ITEM 6. DEVELOPMENT APPLICATION: UNITS 39-41 - 1A COULSON STREET ERSKINEVILLE**FILE NO: D/2014/1703****DEVELOPMENT APPLICATION NO: D/2014/1703****SUMMARY****Date of Submission:** 5 November 2014**Applicant:** Urbis**Architect:** Bates Smart**Developer:** Fridcorp Pty Ltd**Owner:** THE OWNERS - STRATA PLAN NO 74596**Cost of Works:** \$50,220,821.00

Proposal Summary: The subject application seeks consent for a residential flat building between 5 and 7 storeys containing 112 apartments, 17 three storey terraces, basement car parking for 65 cars and associated landscaping.

Summary Recommendation: The development application is recommended for deferred commencement consent requiring the owner of the site to execute the Voluntary Planning Agreement and register this agreement on title prior to the activation of the consent.

Figure 15 – Identifying area of height non-compliance for the residential flat building.

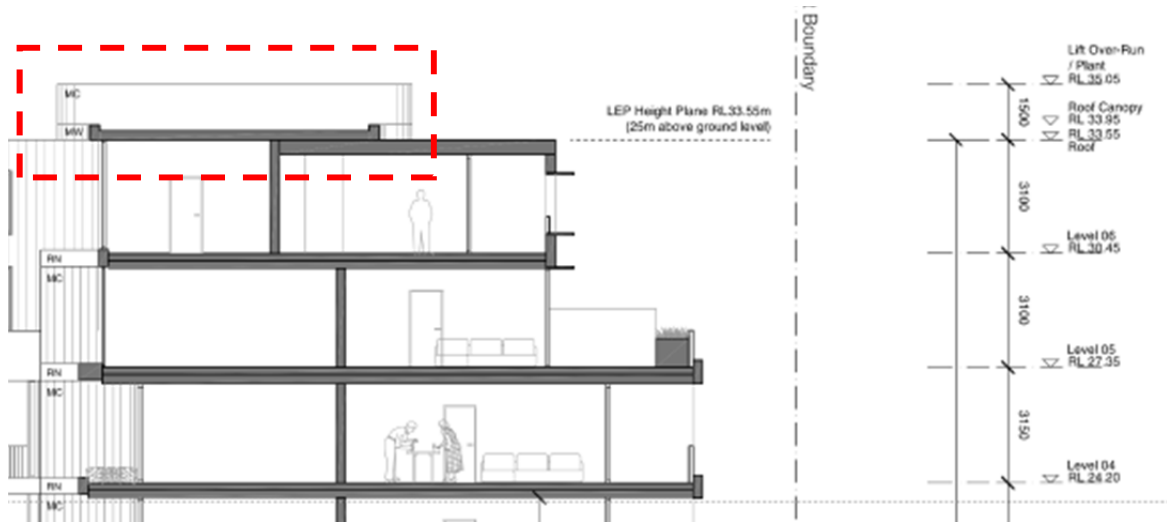
37. The height limit for the residential flat building is 25m. The proposed height is 26.5m, a non-compliance of 1.5m and a variation of 6% to the standard.
38. The non-compliance relates only to the lift overrun, mechanical plant and communal open space roof canopy only, as illustrated in Figure 15. The proposed height variation does not accommodate any gross floor area.

Figure 16 – Identifying area of height non compliance for the terrace houses.

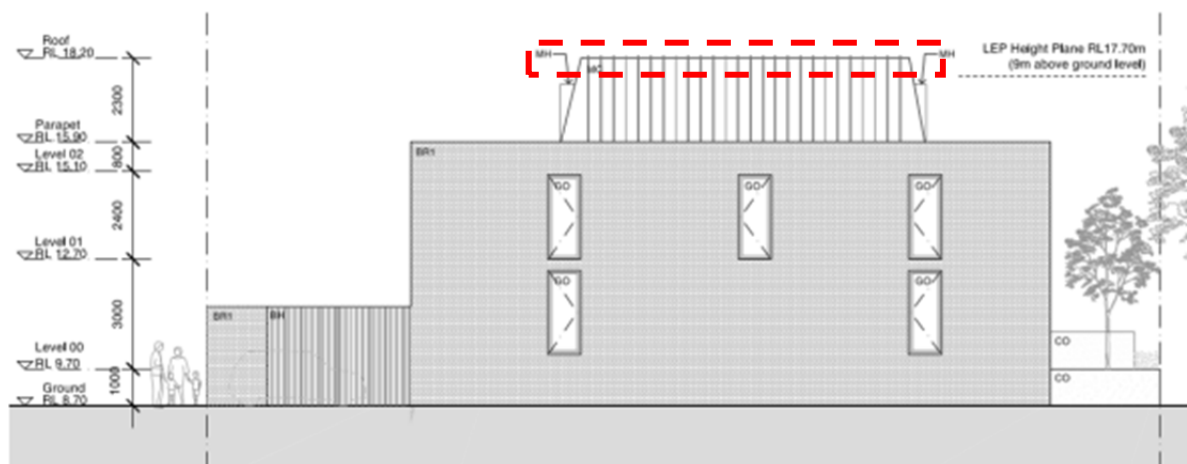
39. The height limit for the terraces is 9m. The proposed height is 9.5m, a non-compliance of 0.5m and a variation of 5% to the standard.
40. The non-compliance results from the need to address flood planning levels under DCP 2012, and provide sufficient floor to ceiling heights.

Figure 17 – Area of non-compliance identified

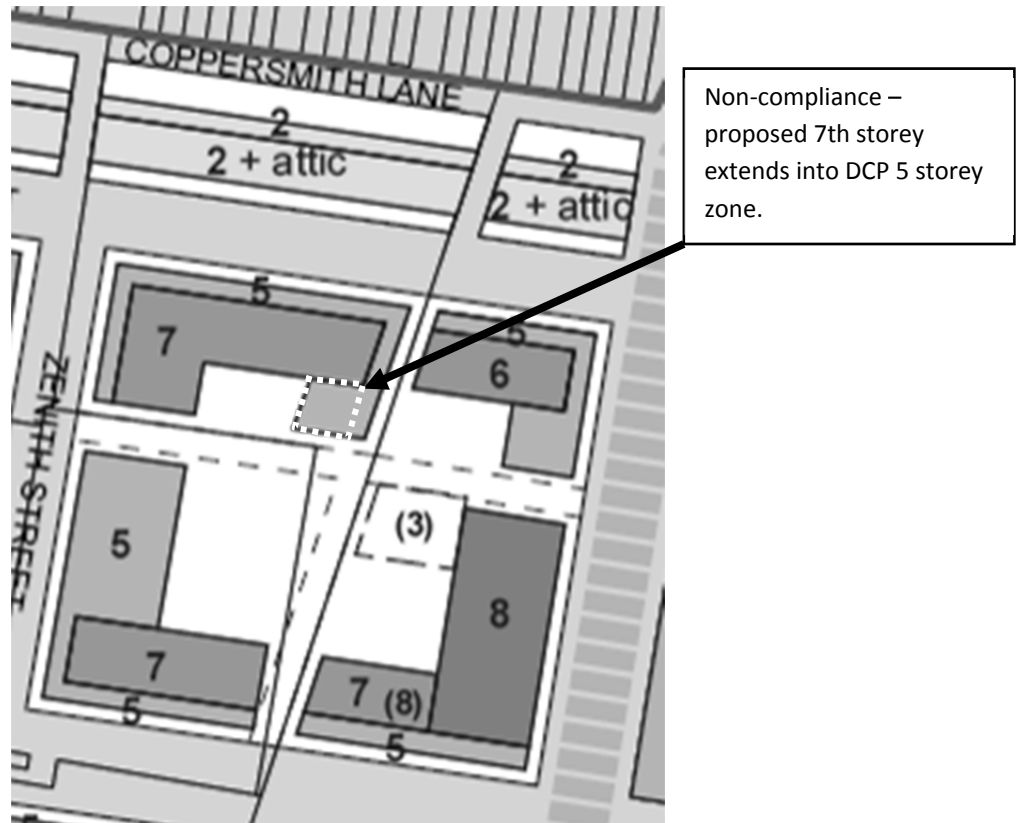
- 48. The DCP 2012 height in storeys control specifies a 5 storey height control in the south eastern portion of the building. The proposal extends the 6th and 7th storey in this location, which results in a breach in the height in storeys control as shown in Figure 17 below.

49. The proposal includes an upper level return to reflect that of the western wing. The additional floor area is compliant with the floor space ratio and height in metres development standards of LEP 2012.

Figure 18 – Demonstrating existing setbacks and likely future development setbacks.

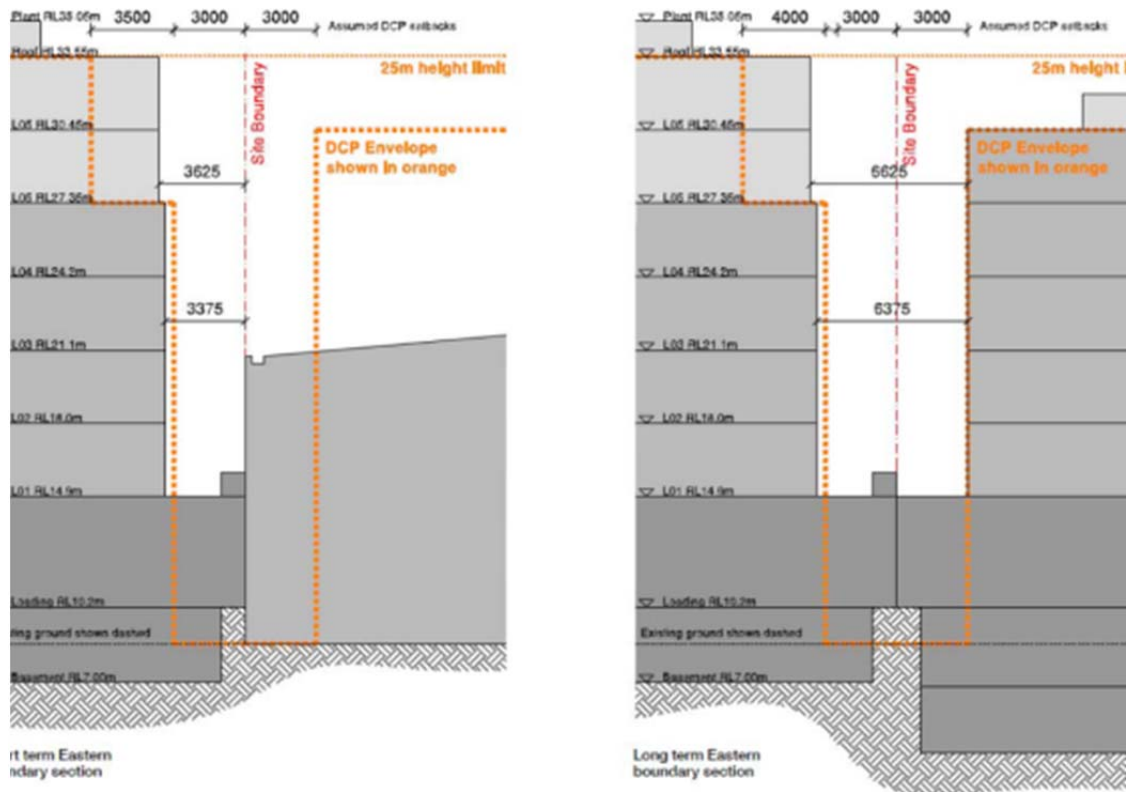
55. However, the DCP 2012 controls requires a 3.3m boundary setback for levels 1 to 4, and 6.5m boundary setback for levels 5 and 6. As such the proposal is compliant for levels 1 to 4, but non-compliant for Levels 5 and 6.
56. The existing warehouse to the east has a nil setback to the boundary of the subject site. Whilst no proposal has been lodged for the future development of this property, the applicant has prepared an indicative plan to demonstrate the likely future potential impact on the setbacks for the eastern units as demonstrated in Figure 18 below.

57. The non-compliance from the RFDC and DCP 2012 controls is acceptable as the design of the building incorporates elements to preserve the amenity for the subject site and for future development to the east.
58. On levels 1 to 4, the principal living areas are set back 6 metres to ensure further separation from the adjacent boundary, and the eastern bedrooms of levels 5 and 6 are fitted with direction louvres to enhance visual privacy to future developments.

Figure 22 Plan of the proposed staggered landscaped setbacks to the ground floor of the residential flat building.

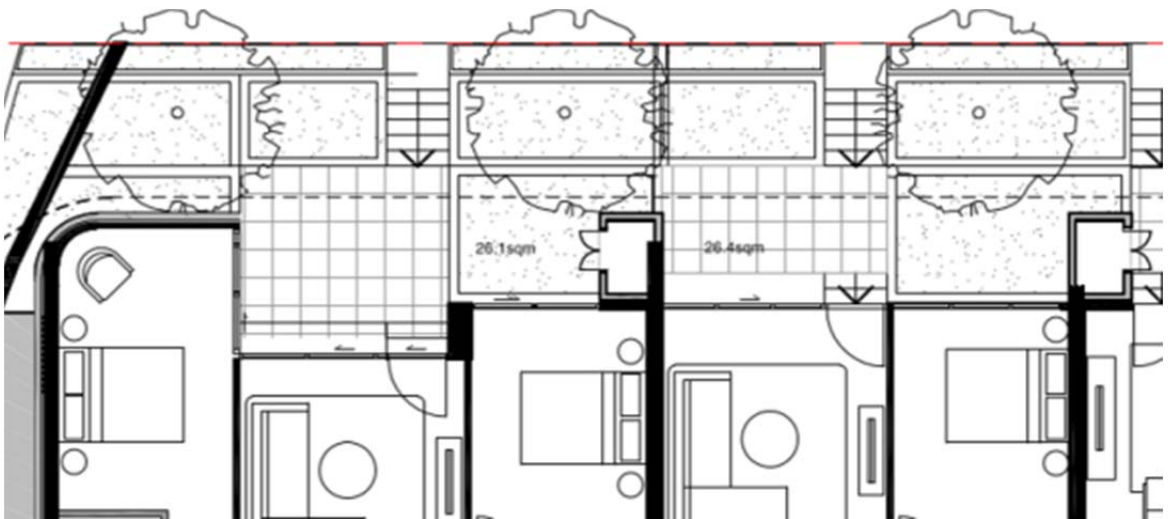
64. Figures 21 and 22 illustrate the typical treatment to the ground floor landscaped area. It is considered that the proposal complies with the objectives of DCP 2012 and will provide a high quality interface with the public domain through the provision of landscaping in the form of trees, shrubs and groundcovers, and a combination of open fences and masonry walls to balance the privacy needs of residents and visual permeability to allow for social interaction. The proposed setbacks are considered to be acceptable.

Figure 25 Detail of landscaping for site (not including dedicated pedestrian walkway to the south).

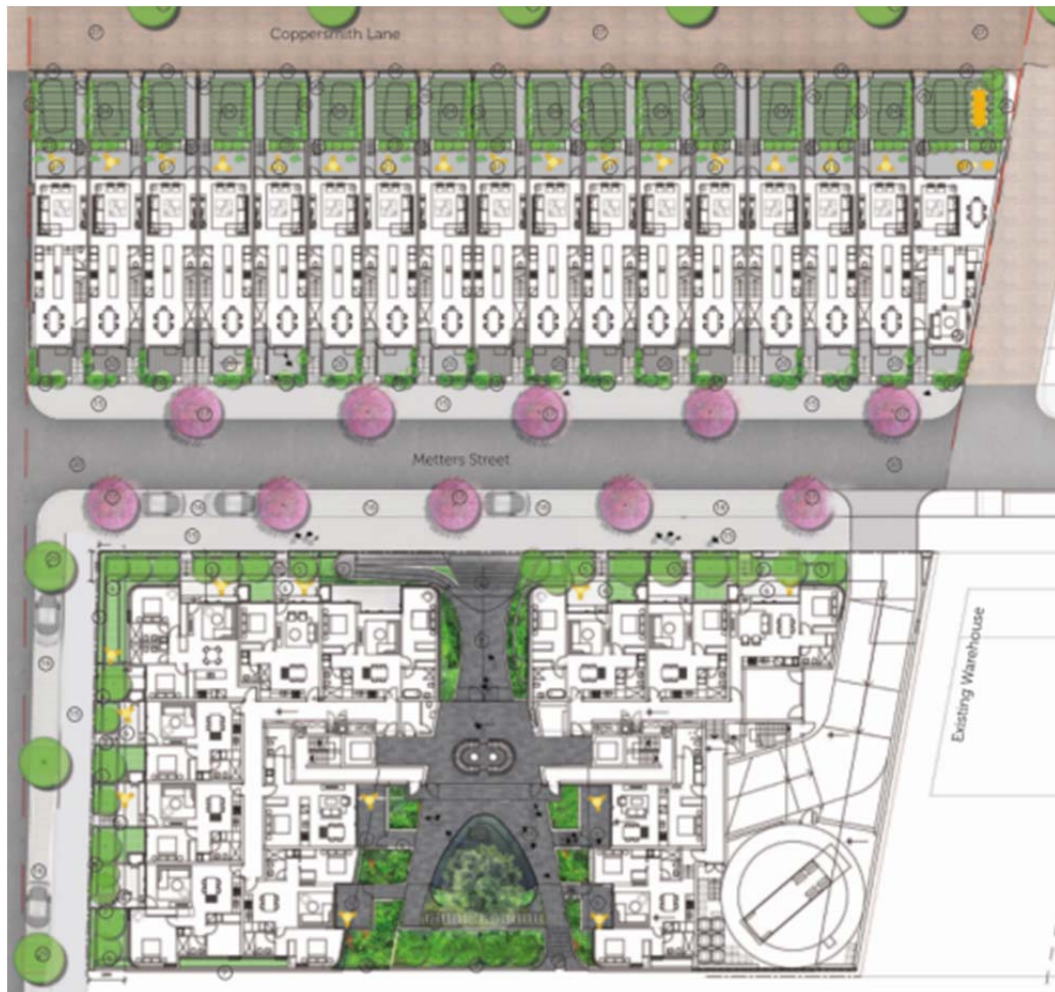
68. The site area for the residential flat building is proposed to be 2,309m² following future subdivision. Of this space, 5.5% (131m²) of the site area is deep soil zone. The reason for the deficiency is due to the following factors.

69. From the subdivision, deep soil is being provided away from the RFB lot in the form of tree pits, and a 101m² dedicated lot as part of the public walkway. Should the dimensions be incorporated into the calculations, the site would be achieving 16% deep soil zone, which would exceed the requirements of the DCP 2012.
70. Design details have been incorporated where possible to maximise deep soil planting zones, including basement realignments, permeable paving and amendments to the terrace houses to provide 11% (739 m²) of deep soil for the site as a whole.
